# Bally Kiss

554.126.v39 GR (1/6/2021)

**First Floor Plan**

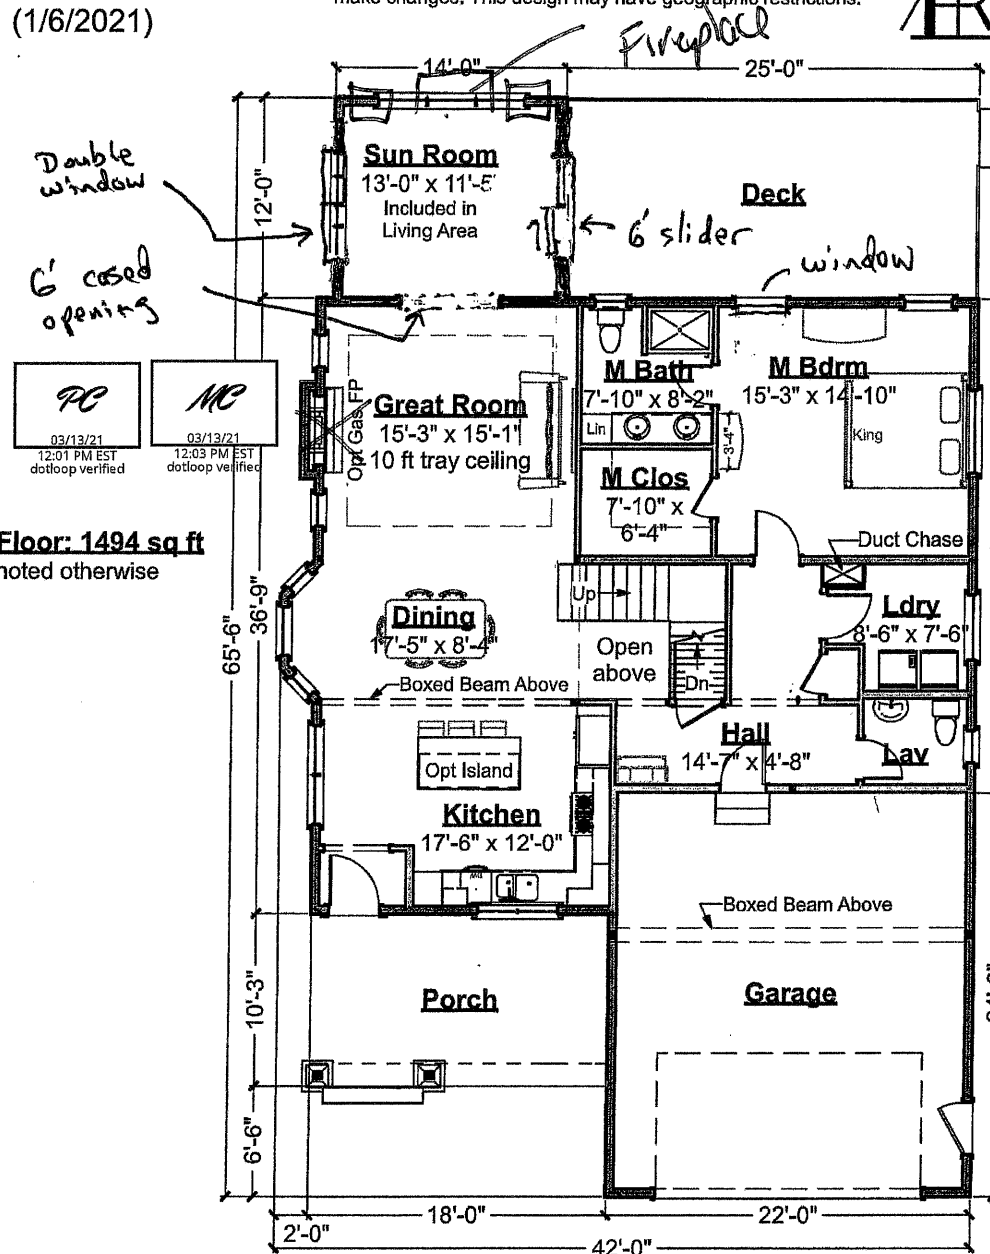
1. FLIP plan  
2. MOVE FP TO SUN ROOM BACK WALL - windows on EACH SIDE  
3. Larger windows in Living Room  
4. TRANSOM window over slider  
5. ADD windows in Garage door
